REMEDIAL ACTION COMPLETION REPORT
PARCEL E2
HUNTERS POINT NAVAL SHIPYARD, SAN FRANCISCO, CA

Response to Comments on the Draft Remedial Action Completion Report, Parcel E-2 Phase II, Hunters Point Naval Air Station, California, December 2019, DCN: APTM-2005-0013-0047

Comments by: Karen Ueno, US Environmental Protection Agency, comments dated March 6, 2020

FIGURE 8
FRESHWATER WETLAND FINAL LEAD EXCAVATION FINAL
CHEMICAL CONFIRMATION SAMPLE GRIDS

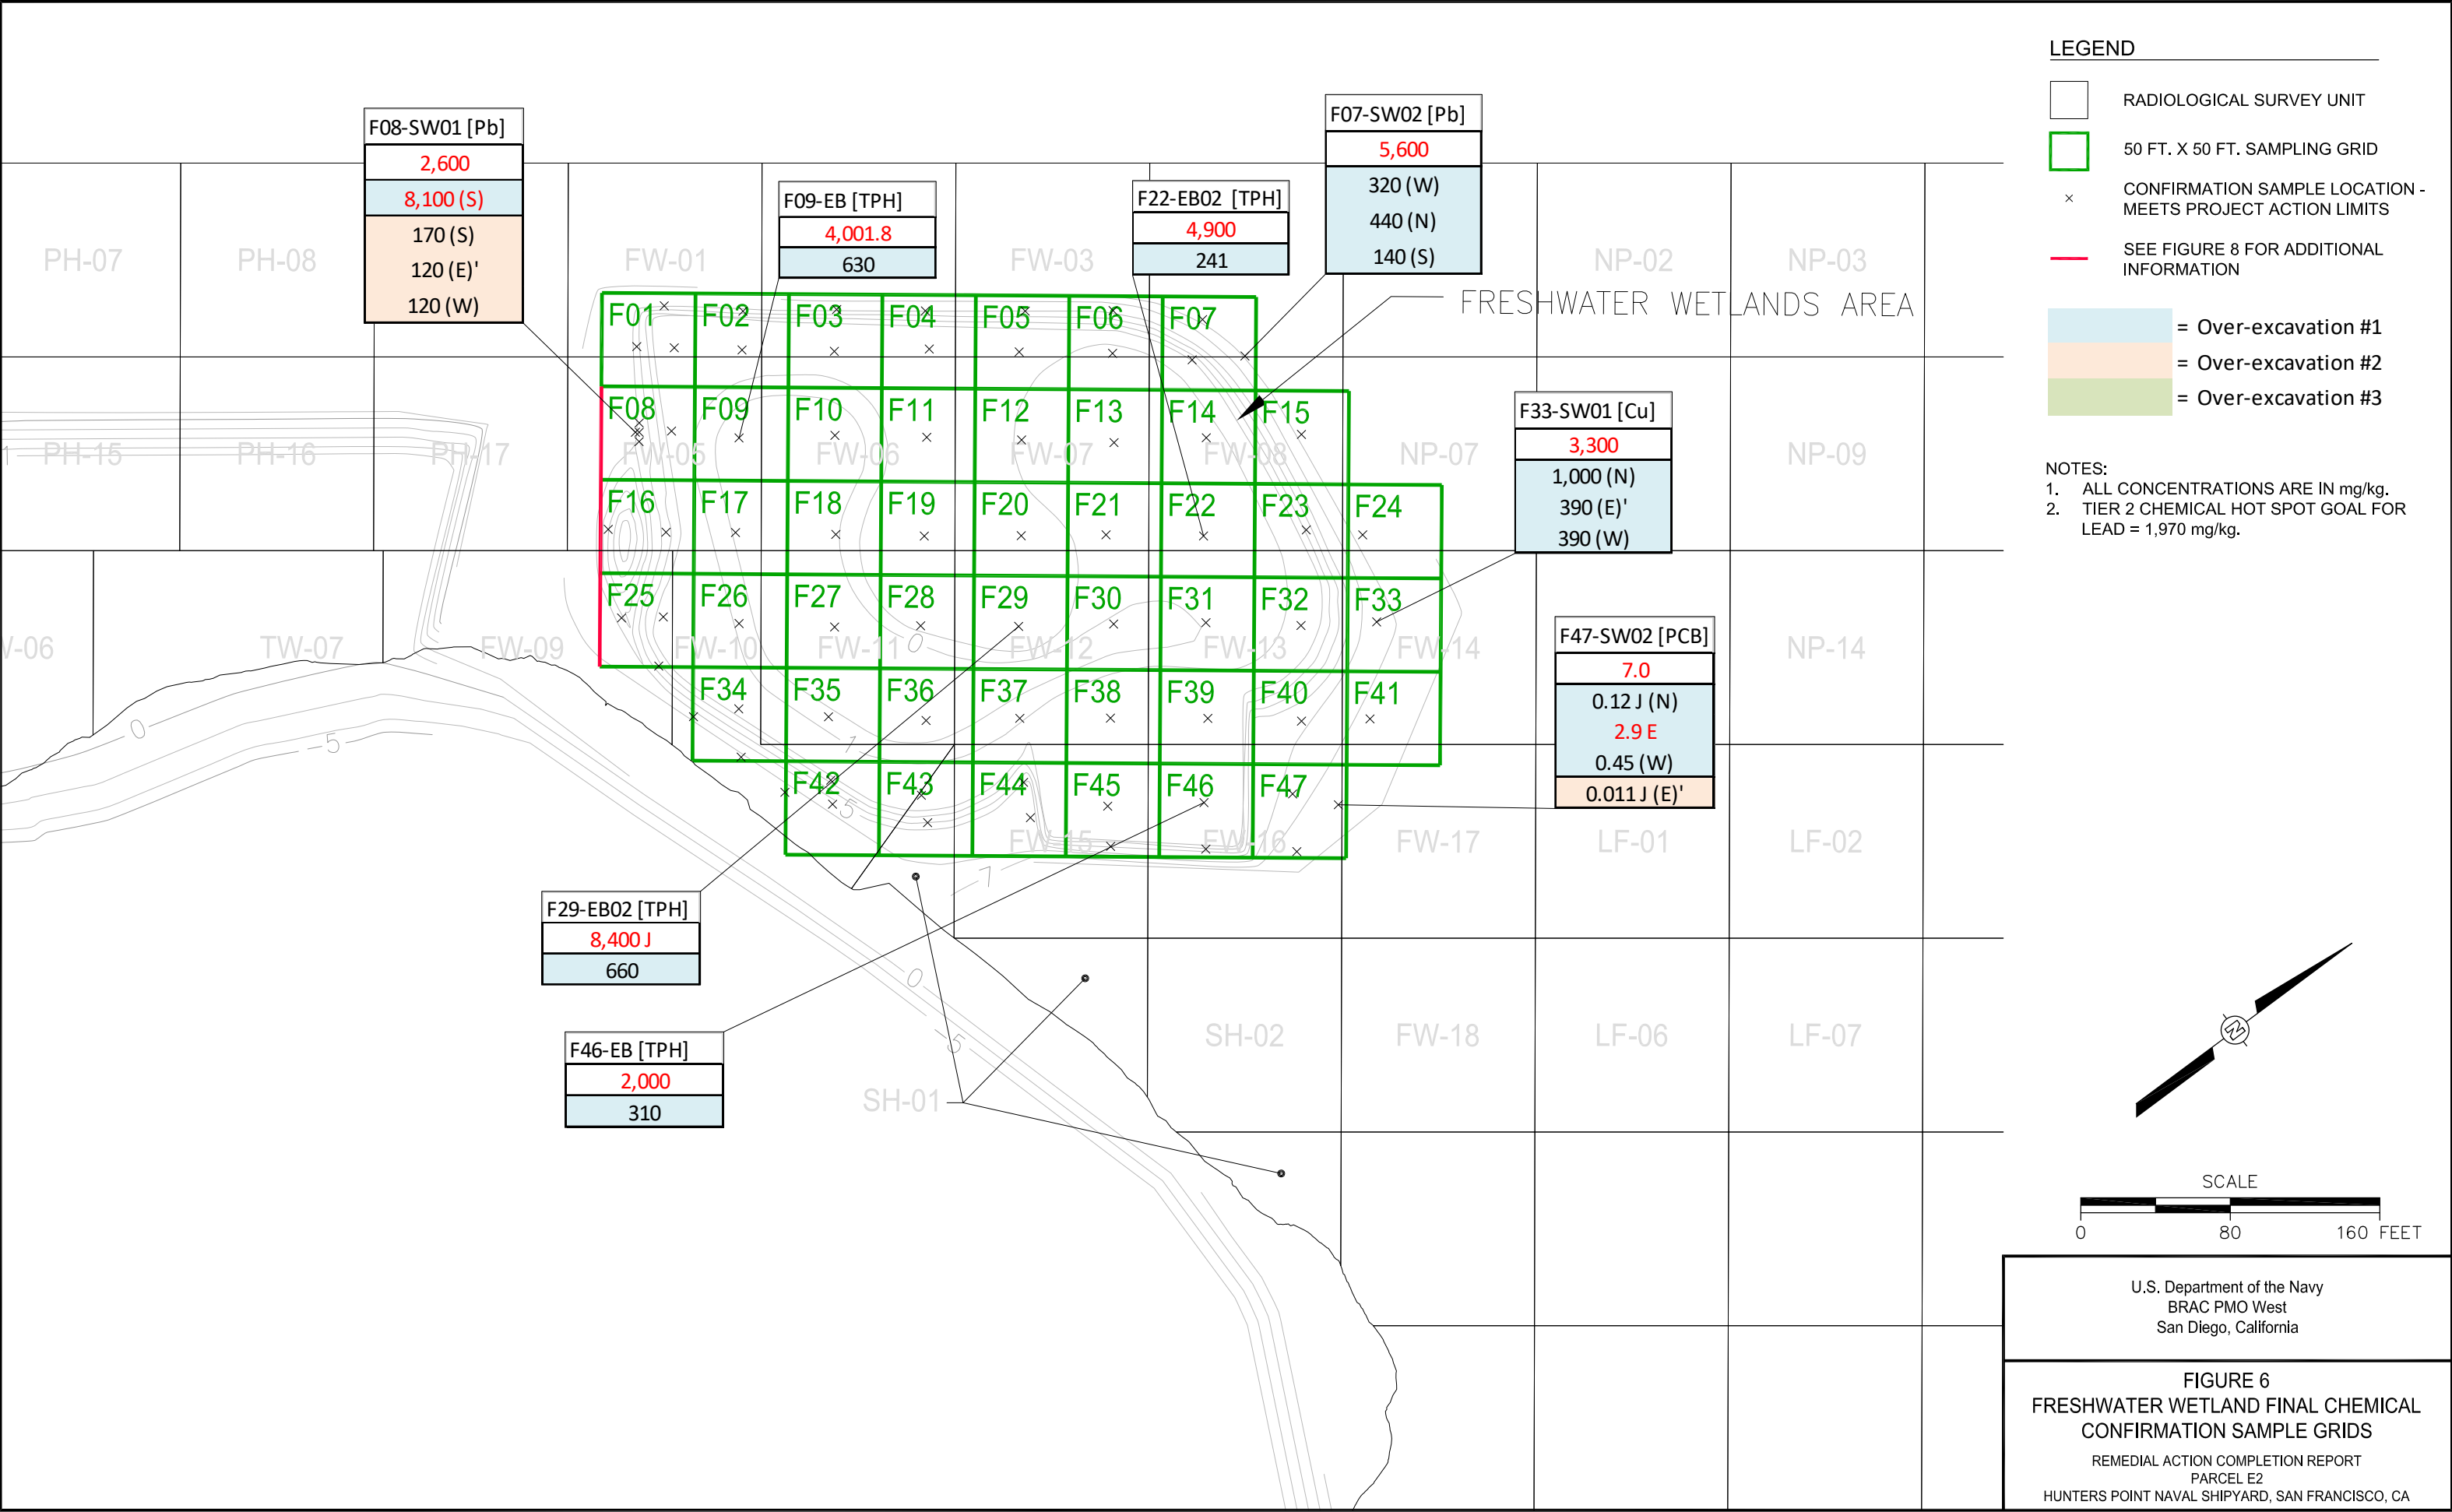
- A. Describe whether or not the bounded area on Figure 2 was actually over-excavated. If it was, then provide acceptable documentation of the work and the results of confirmation sampling and analyses demonstrating the attainment of hot spot goals.

On Figure 2, the planned limits for over-excavation of lead-contaminated soil overlap sampling grids F08 and F16. However, the nomenclature used for the test pit samples includes “F25”, which is also a grid location some distance away from the test pits (and addressed by Comment 6 above).

- B. Confirm that the locations of the test pits and planned over-excavation are as they appear on Figure 2.
- C. It is not clear why for some step-out, sidewall over-excavations three confirmation samples were collected (e.g., FW-SW-F25-SO-002, -003, and -004 on 2/15/18 for the 35,000 mg/kg south sidewall exceedance of 12/20/17), and for other excavations only one sample was collected (e.g., FW-SW-F25-SO-005 on 3/6/18 for the 48,000 mg/kg south sidewall exceedance on 2/15/18 and FW-SW-F25-SO-006 on 3/6/18 for the 46,000 mg/kg west sidewall exceedance on 2/15/18). Explain the rationale for collecting either one or three sidewall confirmation samples. Identify where in the Phase II RAWP the sampling frequency is described.

8. Appendix X describes an investigation in the “Metal Slag and Ship Shielding Area.” Six five-foot deep by four-foot wide excavations were completed to characterize the extent of lead contamination (Figure 4). Bottom samples were collected at 5 feet and sidewall samples at 2.5 feet (only the sidewall facing the Freshwater Wetland was sampled). Samples were analyzed for lead, and the results are summarized below.

The level of detail provided for this excavation work is inadequate. The Phase II RACR, among other things, should:

- b. The referenced figure has been rechecked. Figure 8, which shows the final bottom and sidewall excavation for the final lead excavation, has been added to the RACR.
- c. During the initial phases of chasing the lead, the bottom and sidewall of FW-SW-F25, the confirmation samples were analyzed to ensure that the excavation limits are shown in Figure 8. The concentrations in the excavation limits are shown in Figure 8. The bottom and sidewall confirmation samples were analyzed at the RAWP required frequency.
- d. New RACR figure 8 shows the lead excavation from initial to final. RACR Table X, shows the lead results from initial to final.

No soil exceeding lead criteria were left in the Metal Slag and Ship Shielding Area. Figure 8 (Figure 8) has been added to the RACR to show the lead results of final confirmation sampling and the lead results of final confirmation sampling added to summarize the progression of sampling.

FIGURE 7
TIDAL WETLAND FINAL CHEMICAL
CONFIRMATION SAMPLE GRIDS
REMEDIAL ACTION COMPLETION REPORT
PARCEL E2
HUNTERS POINT NAVAL SHIPYARD, SAN FRANCISCO, CA

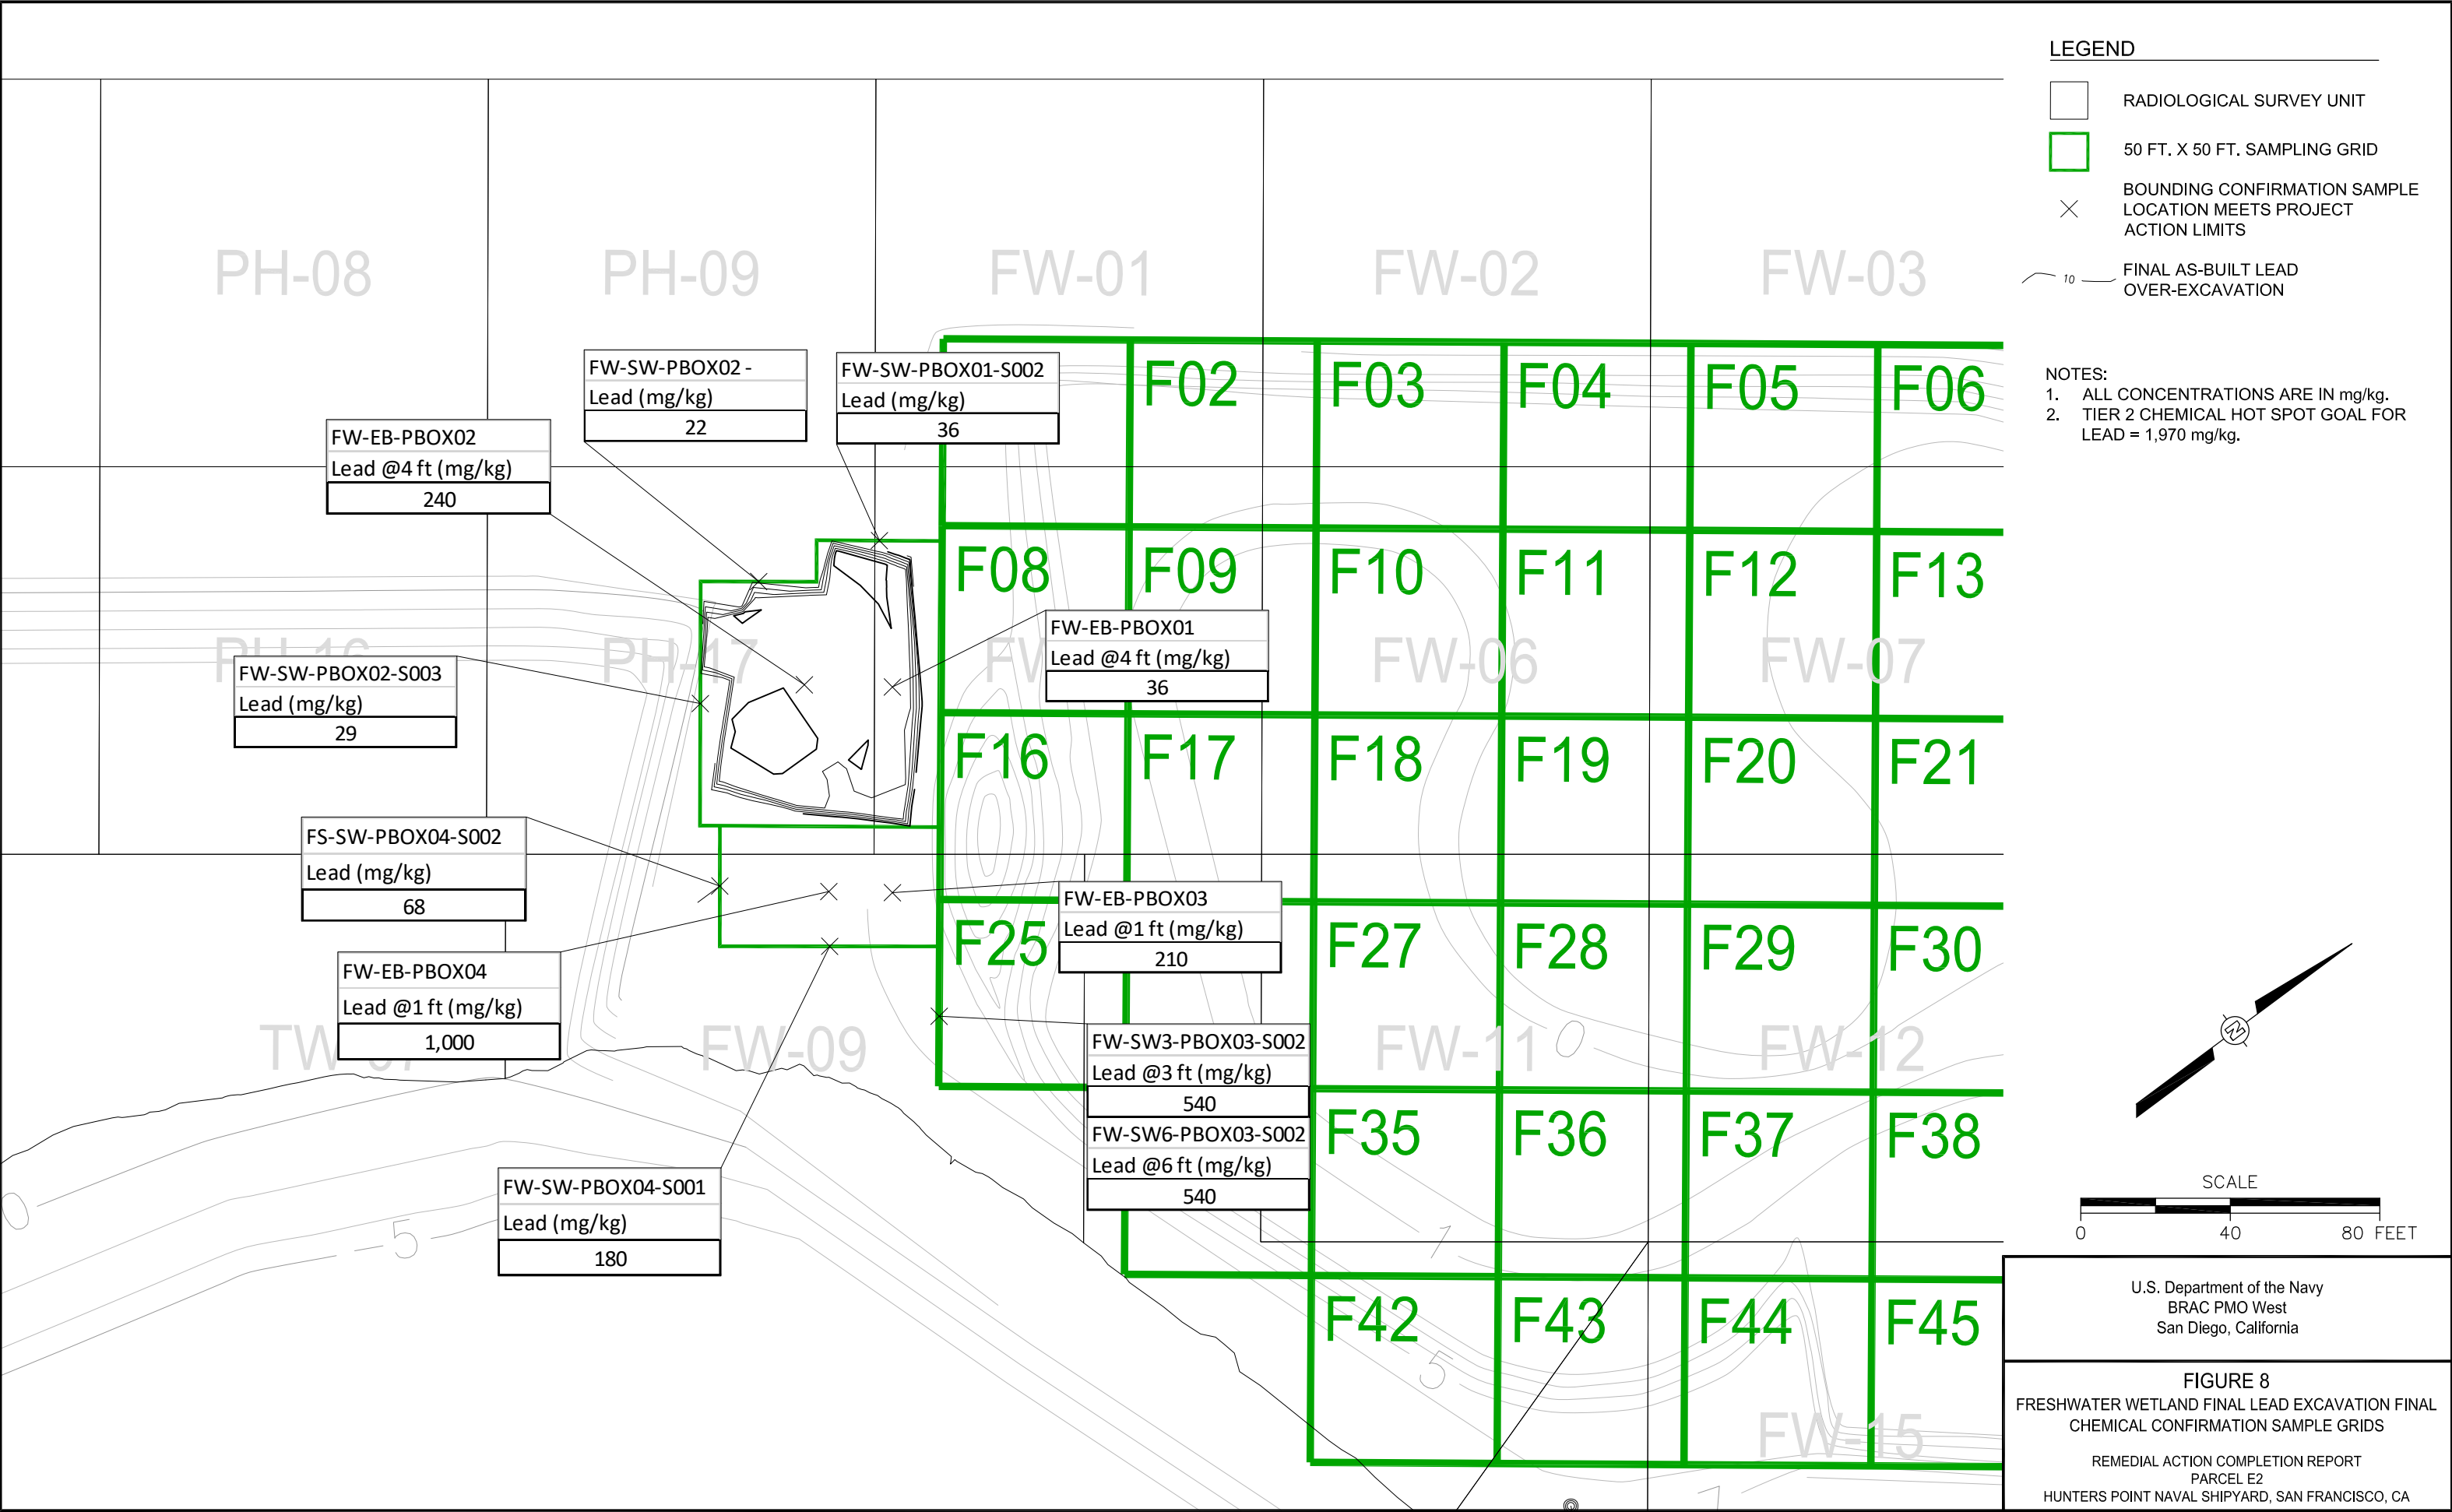
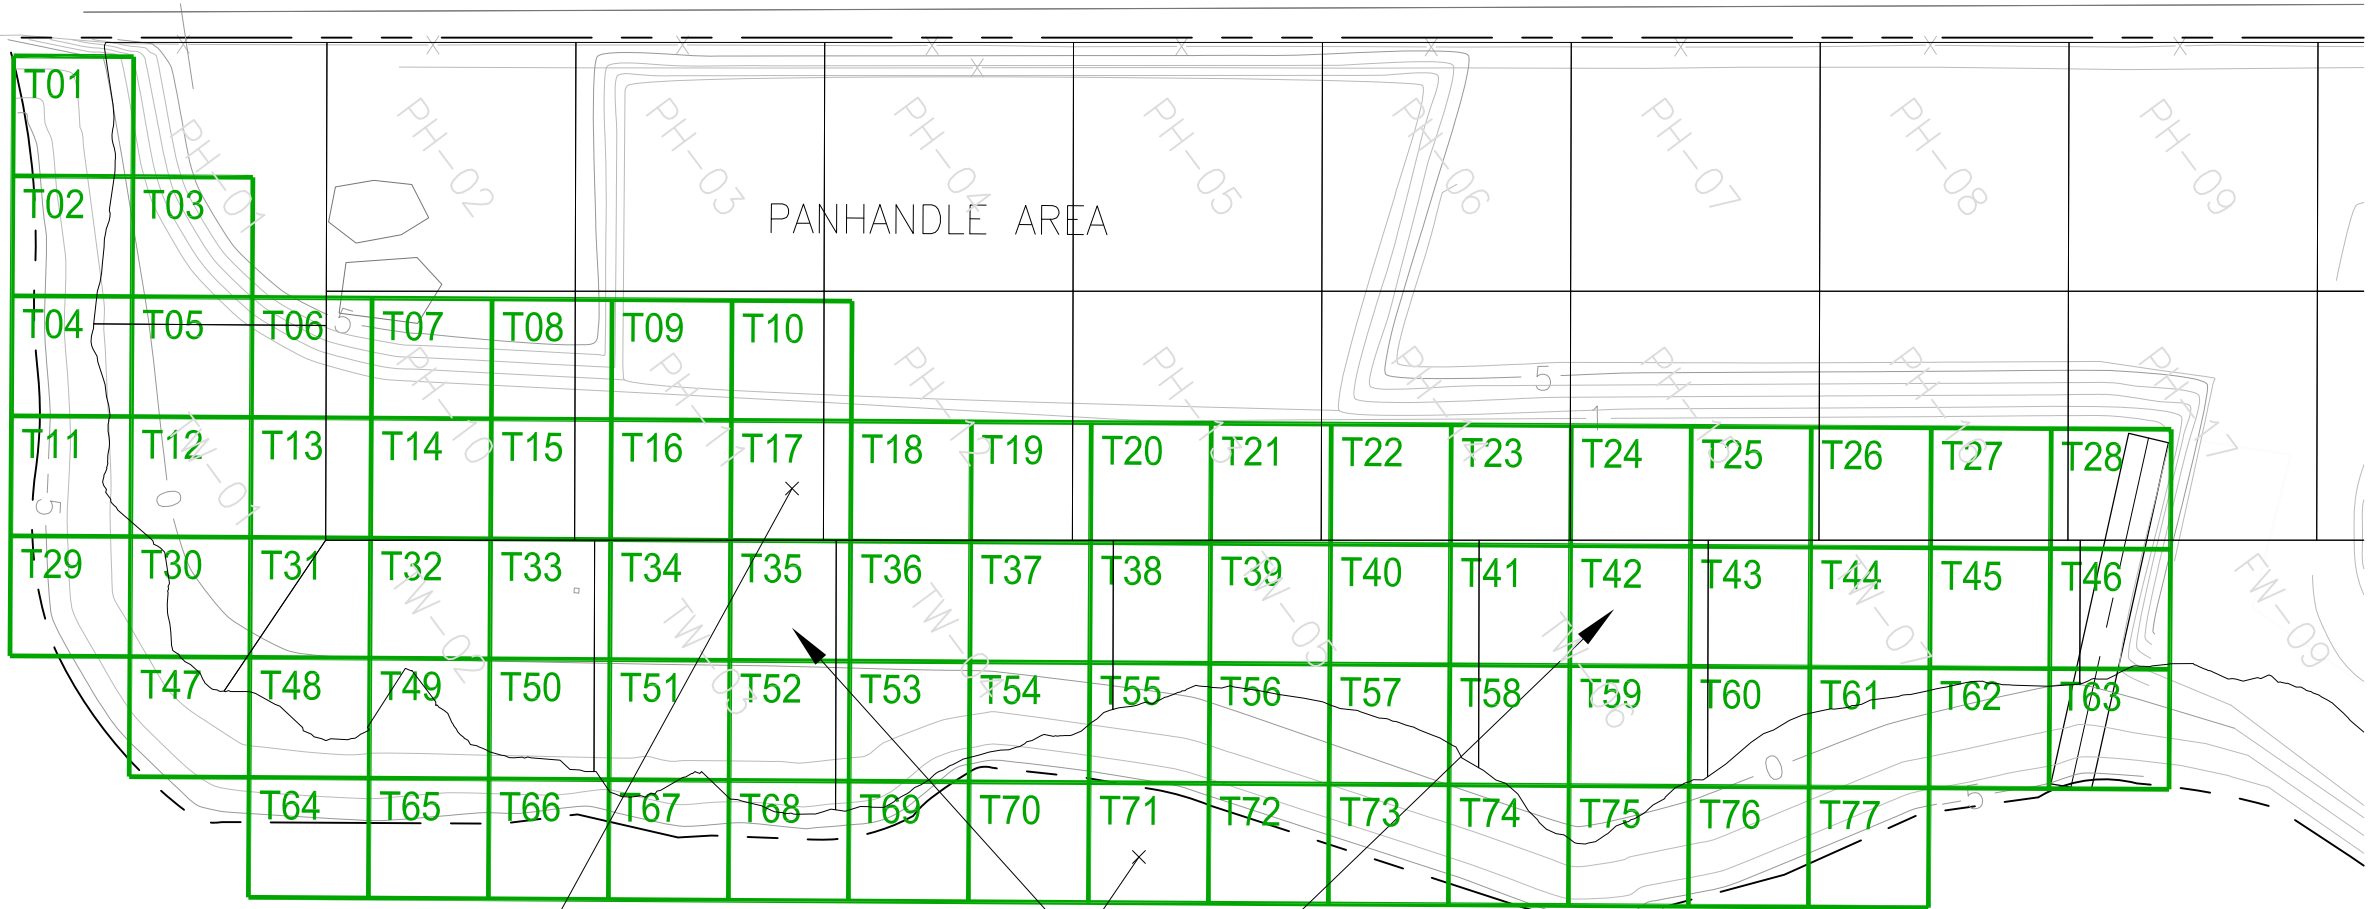
<p>2. The Phase II RACR states on page 3-10 that “chemical confirmation results exceeded the appropriate hot spot goals in sample grid locations (SU freshwater [FW]) FW-7, -08, -09, -25, -33, and -47 (Figure 5).” The survey unit (SU) grid shown on Figure 5 is not the sampling grid layout shown on multiple figures presented in Appendix G and Appendix X, which was used for cleanup of Freshwater Wetland soil.</p> <ol style="list-style-type: none"> Refer to the appropriate figures and sample grid system There was a hot spot goal exceedance for lead at grid location F46. Describe this hot spot goal exceedance and remedial action. At grid locations F22 and F29, there were hot spot goal exceedances for combined total petroleum Hydrocarbons (TPH; or summed gasoline-range hydrocarbons [TPH_{GRO}] and motor oil-range hydrocarbons [TPH_{MORO}]). Describe these hot spot goal exceedances and remedial actions. 	<p>The Radiological Survey Unit Grids are not shown in the Tidal Wetlands excavation chemical confirmation sampling results. Soil exceeding lead or TPH criteria were not found in the Tidal Wetlands or Freshwater Wetland. Exceedances were clarified, the RACR has been revised to more accurately reflect the figures associated with the Tidal Wetland excavation, confirmation sampling to the appropriate figures.</p>
